# **PUBLIC HEARING MEMORANDUM**

SUBJECT: Petition #32-21, for SPECIAL PERMIT/SITE PLAN APPROVAL to allow three single-family

63-65 Broadway

### **ZONING REVIEW MEMORANDUM**

# Proposed Site Plan

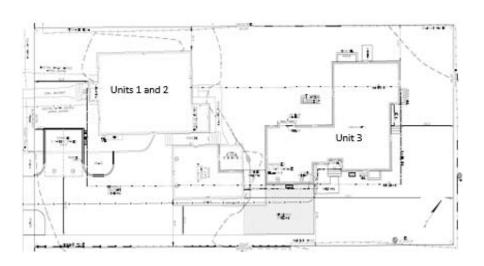
dwellings require a minimum of 25-foot setbacks. While Unit 3 maintains the existing setbacks, the rear setback is being reduced from 100 feet to 25.3 feet between Unit 3 and the eastern boundary. The side setbacks that require a special permit are those which maintain the existing setbacks. While the petitioner requires relief for the side setbacks, the setbacks that require the waiver are the existing setbacks. The conversion of the existing two family to single family attached dwelling units triggers more restrictive setbacks. The proposed Unit 3 meets the 25-foot setback from the southeastern boundary. The proposed side setback for Unit 3 is 14.7 from the northwestern boundary and is greater than the existing setback.

The site complies with many standards of the single family attached dwelling building type. The site has a proposed lot area per unit of 6,000 square feet, greater than the 4,000 square feet required. The waivers for the side setbacks, and driveway within 10 feet of a side property line largely reflect existing conditions of the site.

Proposed Front Elevation-Unit 3 *View from southeastern property line*

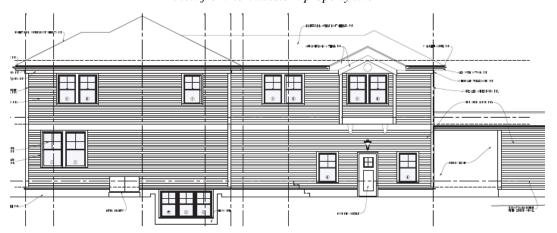
The floorplans of Unit 3 indicate a kitchen would be installed in the basement and on the first floor. The petitioner should clarify whether this is the intent and if so, the petitioner should discuss this arrangement with Inspectional Services.
